Service Bulletin No. 606  
Engineering Aspects are  
FAA Approved

SUBJECT: Correction of Engine Data Plate on IO-540-AE1A5 Engines

MODELS AFFECTED: IO-540-AE1A5

Figure 1  
Data Plate

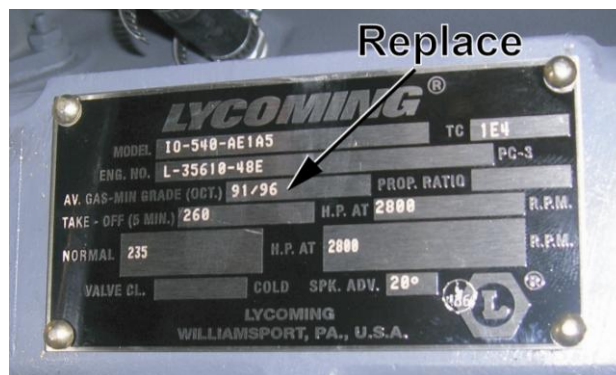
Due to an administrative error, 91/96 could be incorrectly imprinted on all existing IO-540-AE1A5 data tags issued before July 17, 2013.

USE OF 91/96 FUEL COULD CAUSE DETONATION AND MECHANICAL DAMAGE TO THE ENGINE. IF YOU HAVE USED THE INCORRECT FUEL FOR YOUR ENGINE, REFER TO THE LATEST REVISION OF SERVICE BULLETIN NO. SB 398.

The correct fuel to use in an IO-540-AE1A5 engine is 100/100LL, per the latest revision of Service Instruction No. SI 1070.

1. Remove the existing 91/96 notation on the engine data plate (Figure 1) with a vibropeen or other similar device.
2. Stamp 100/100LL on to the data plate. The stamp must be clearly legible.
3. It will be the sole responsibility of the altering agent to record compliance with this Service Bulletin in the permanent engine records and/or engine logbook.
